CITY OF RIVERSIDE, CALIFORNIA
DEPARTMENT OF PUBLIC WORKS

CYPRESS AVE.
NORTHERLY SIDE
460'± E'LY. OF ℄ OF TYLER AVE.
C.U.P. C31-645 & R.S. 934

PROJECT NO. L5-13111
R-1086
SHEET 1 OF 1
FILE NO. 3309

TYPICAL SECTION — CYPRESS AVE.

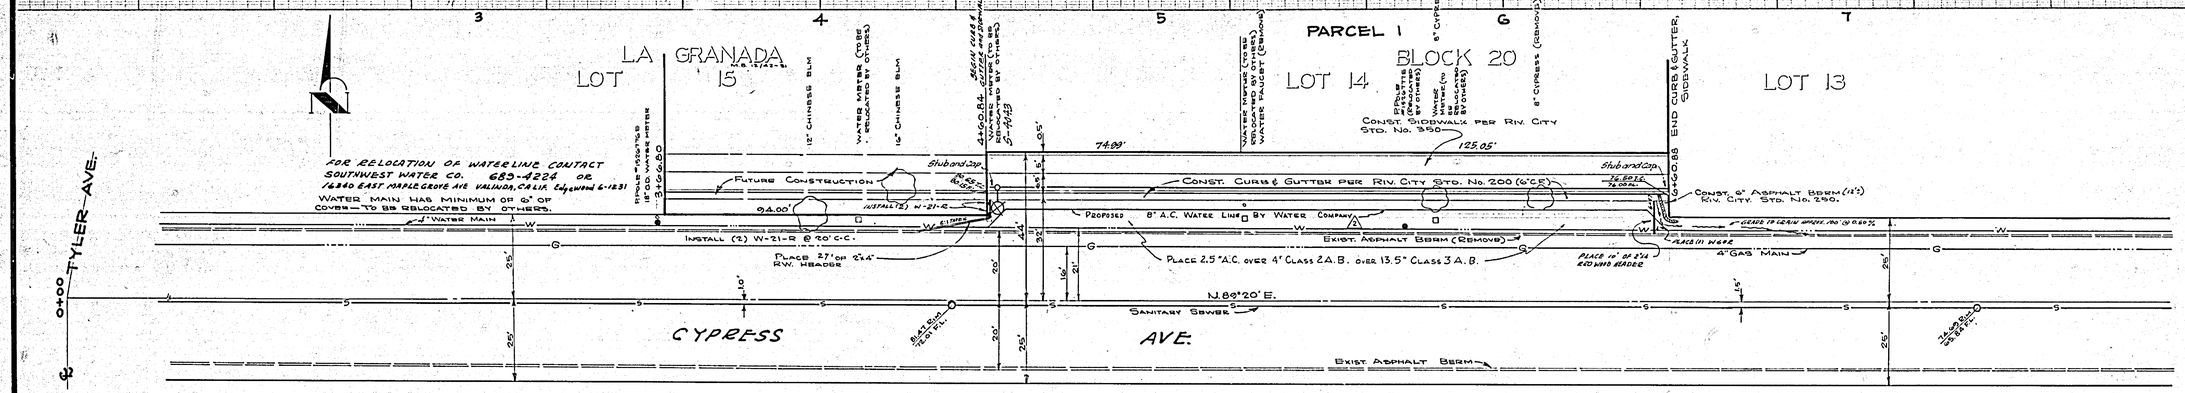
4. GRADING WILL REQUIRE A PERMIT UNDER ORDINANCE 3093 FOR A CUT OR FILL EXCEEDING 100 CUBIC YARDS, OR A FILL OVER ONE FOOT IN DEPTH.
5. ~~THE DEVELOPER SHALL ARRANGE FOR A TEST OF THE SOIL AT THE SUBGRADE LEVEL BY A SOILS ENGINEER. THICKNESS OF PAVEMENT AND THICKNESS AND TYPE OF AGGREGATE BASE SHALL BE DETERMINED BY THE SOILS ENGINEER AND SUBMITTED TO THE CITY OF RIVERSIDE FOR APPROVAL PRIOR TO CONSTRUCTION.~~ △

① PLACE OVERLAY TO PRODUCE A SMOOTH CROWN SECTION
② REMOVE EXISTING BERM AT FLOW LINE.
△ ③ PLACE 2½" A.C. OVER 4" CLASS 2 A.B. OVER 13½" CLASS 3 A.B.
④ CONST. CURB & GUTTER PER RIV. CITY STD. NO. 200. (6" C.R.)
⑤ CONST. SIDEWALK PER RIV. CITY STD. NO. 350

MARK	REVISIONS	APPR.	DATE
△	Added Base Requirements 4/21/67		4/7/67
△	Added Proposed Water Line 7/25/67		7/27/67
